## MATANUSKA-SUSITNA BOROUGH PLANNING COMMISSION AGENDA

October 21, 2024  
REGULAR MEETING  
6:00 p.m.

**Resolution 24-31** A Conditional Use Permit In Accordance With MSB 17.30 — Conditional Use Permit For Earth Material Extraction Activities, For The Extraction Of Approximately 7,500,000 Cubic Yards Of Earth Material From An Extraction Site Of 153 Acres Within Three Parcels Totaling 235 Acres On 7955 E. Bogard Road, 3182 N. Trunk Road, 7801 E. Glade Court, Tax ID#S 18N01E27A002, 18N01E27D001, 18N01E27D002. (Applicant: Dan Steiner, P.E. For Central Gravel Products; Staff: Peggy Horton, Current Planner)

Planning and Land Use Department  
Development Services Division  
Central Gravel Products – Gravel Pit - Application for Condition Use  
Response to MSB Comments

SHEET  
C3.0

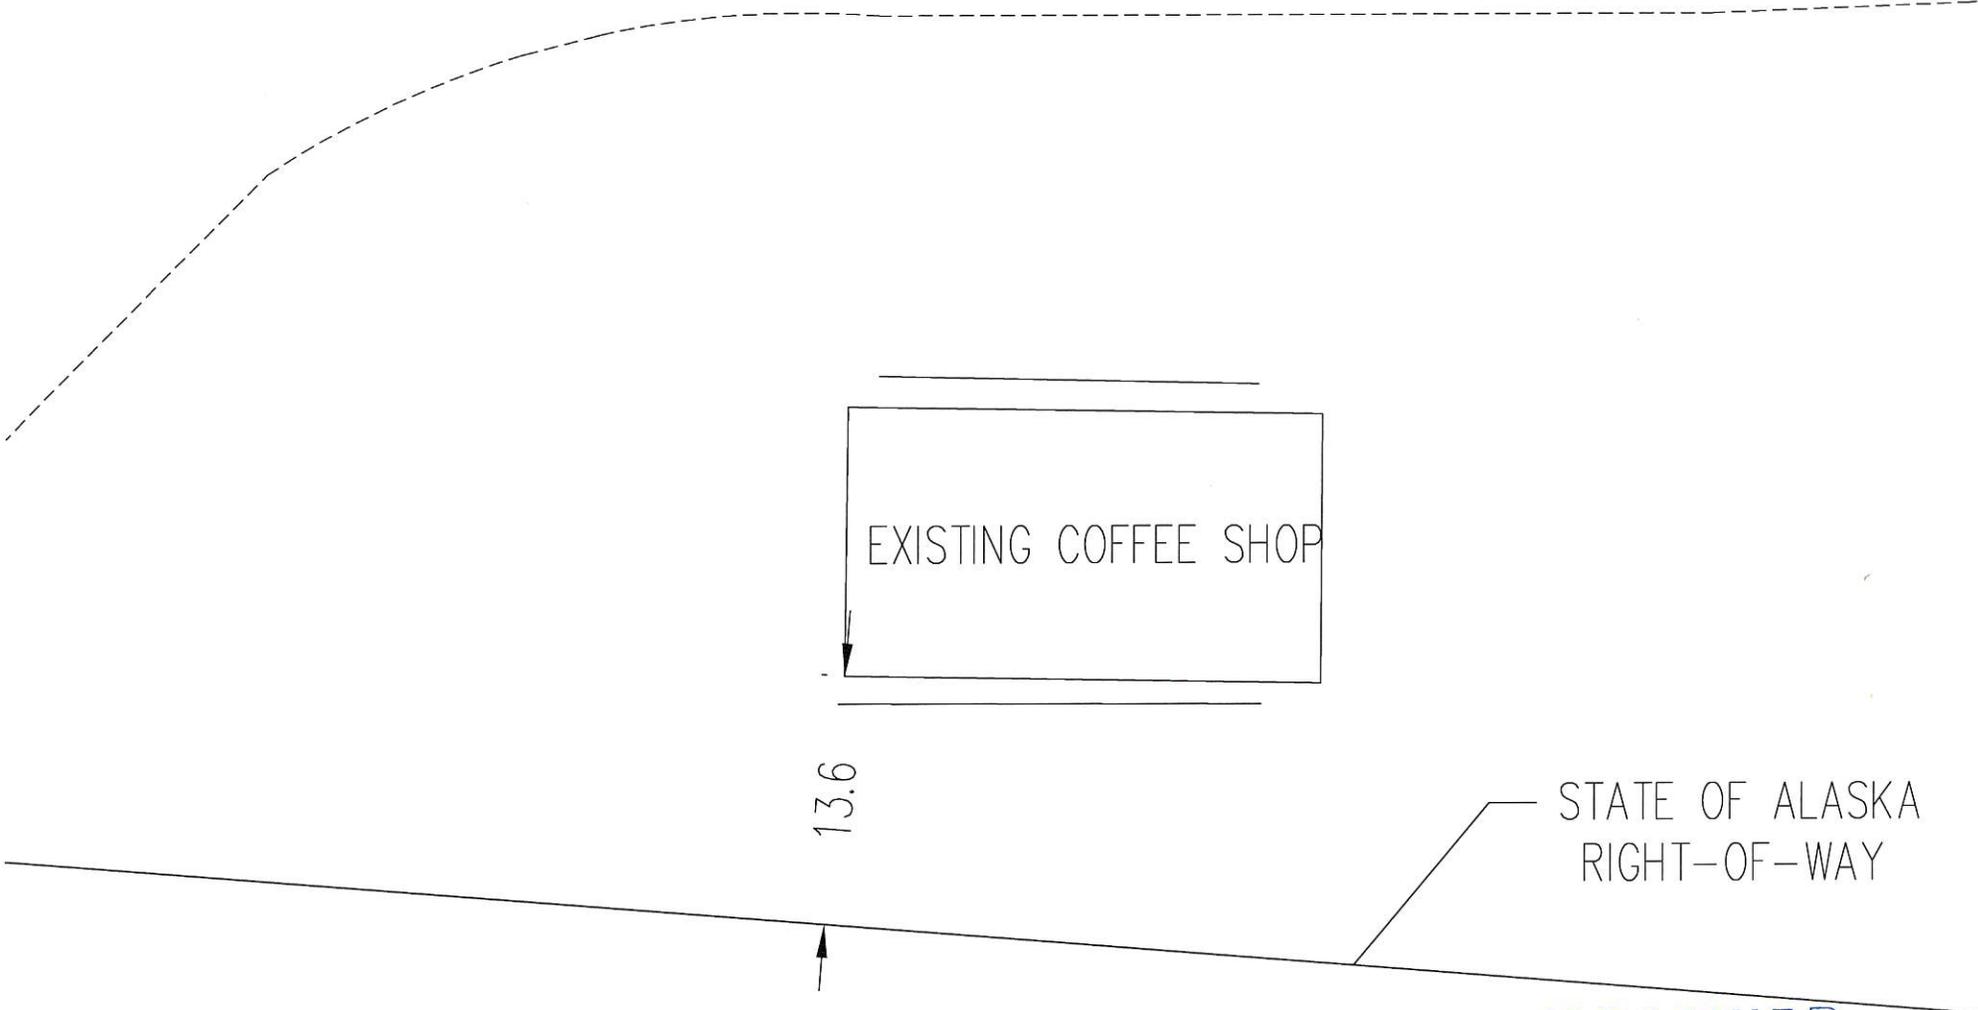
11. Provide a separate reclamation plan meeting the standards of MSB 17.28.063 & 17.28.067. Staff will not extract the information from the DNR reclamation application material. Address each item under MSB 17.28.063 and 17.28.067.

Notes have been added to the reclamation plan that addresses the items in the sections referenced. See Sheet C3.0
